# Autumn Circle - 300 Webster St. Residential Subdivision

## Staff Report

December 10, 2014

Re: Town of Hudson Planning Board Review  
Autumn Circle, 300 Webster Street  
Tax Map 128, Lots 7 & 8; Acct. #1350-852  
CLD Reference No. 03-0249.1430

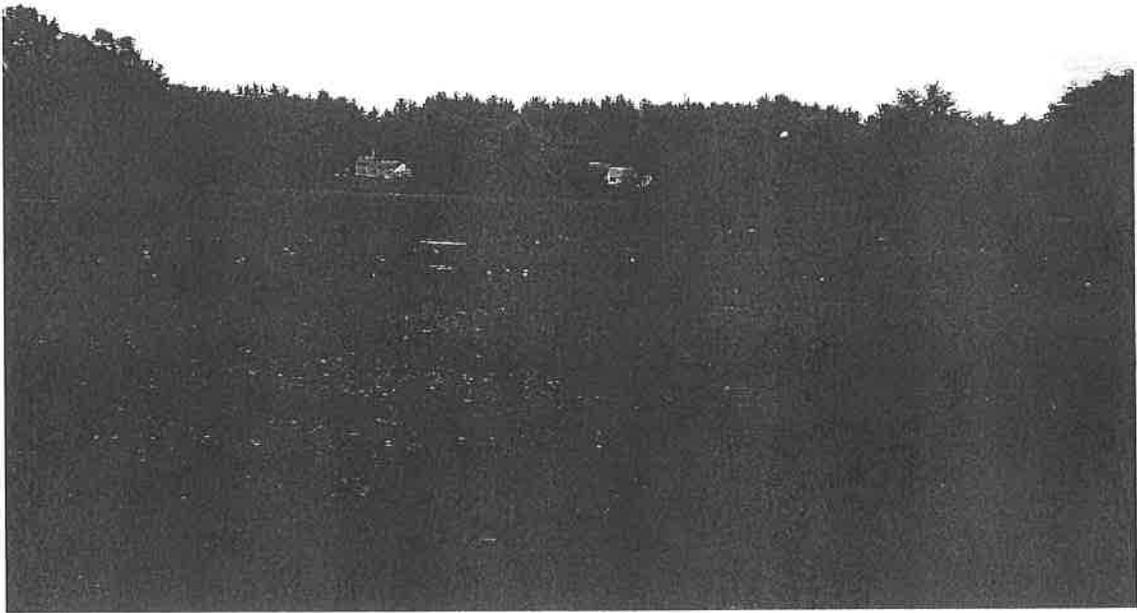
*The site photos depict critical areas of the site, i.e. Shoreland and wetlands, which happen to be wooded and undisturbed. However, the majority of the site is grass. The site is currently a hay field and hayed multiple times per year to keep the grass short. Below are photographs showing the fields.*

SCALE: 1" = 40'  
 HUDSON: MAP 128; LOT 7 & 8  
 LITCHFIELD: MAP B; LOTS 1-1 & 1-2  
 PROJECT NO: 07-0511-4A SHEET 6 OF 23

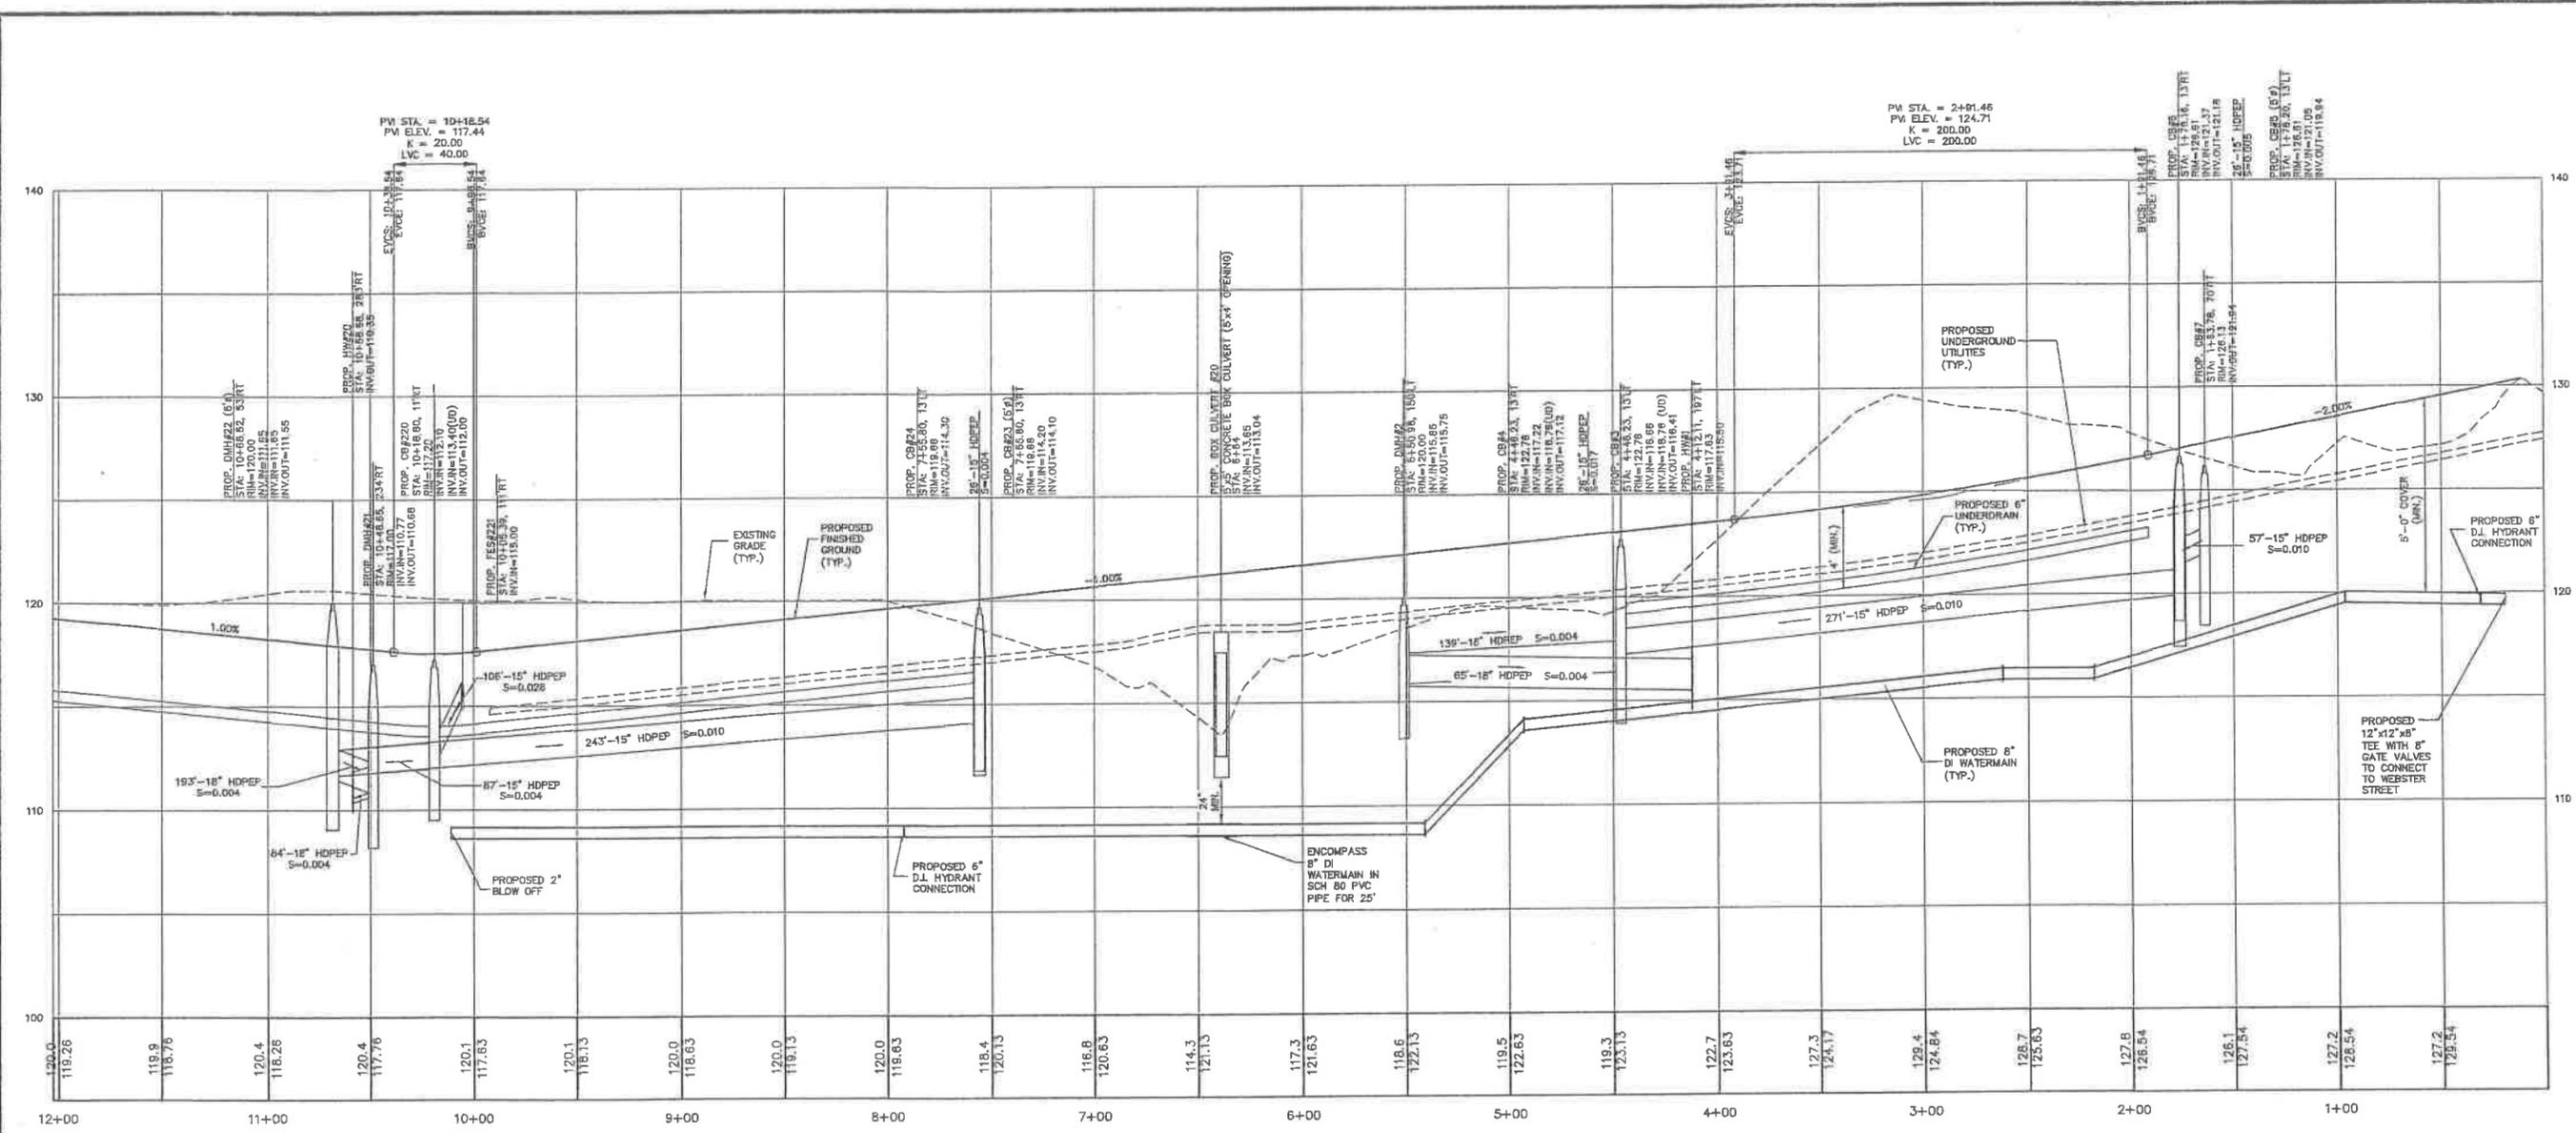
1. On Sheet 6, please review the proposed grading of pond 2P. It appears that contour 118 does not tie in properly. If changes are made to the storage of the pond, please be sure to update the drainage report.

5. The Box Culvert proposed in the AOT permit application (Sheet 6/22) appears to result in some uncompensated loss of habitat. We recommend that the planned wetland buffer in the way of the culvert be expanded 30'-50' upstream and downstream to more fully compensate for the loss of habitat.

*Note #9 has been added to sheet 6.*

TYPICAL ROADWAY CROSS SECTION  
NOT TO SCALE

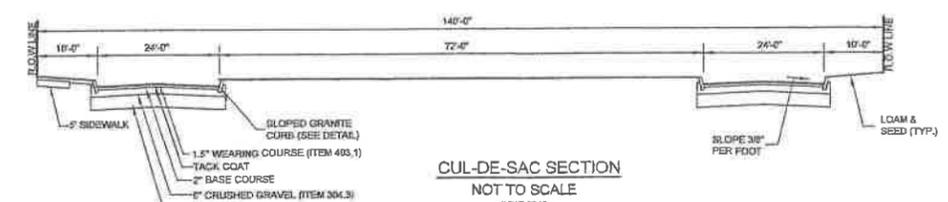
- j. HR 289 Attachment 3. The applicant has detailed a 1.5" wearing course on the typical roadway cross section, but calls out a 1" thick wearing course on other details. The applicant should correct the discrepancy.

CONCRETE BOX CULVERT FOUNDATION AND BACKFILL DETAIL

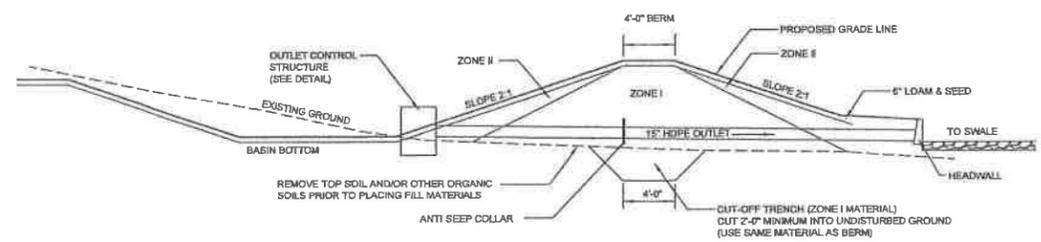
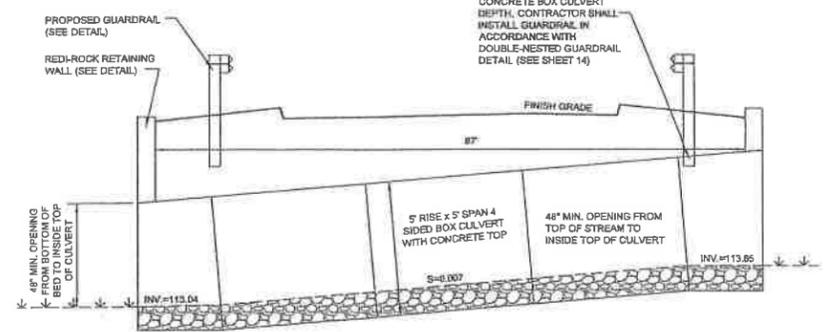
- f. HR 289-18.R. and HR 289-26.B.(8) Proposed end treatments are not shown for the box culvert. Also, the box culvert detail calls for a three-sided box culvert but the detail shows a four-sided structure.
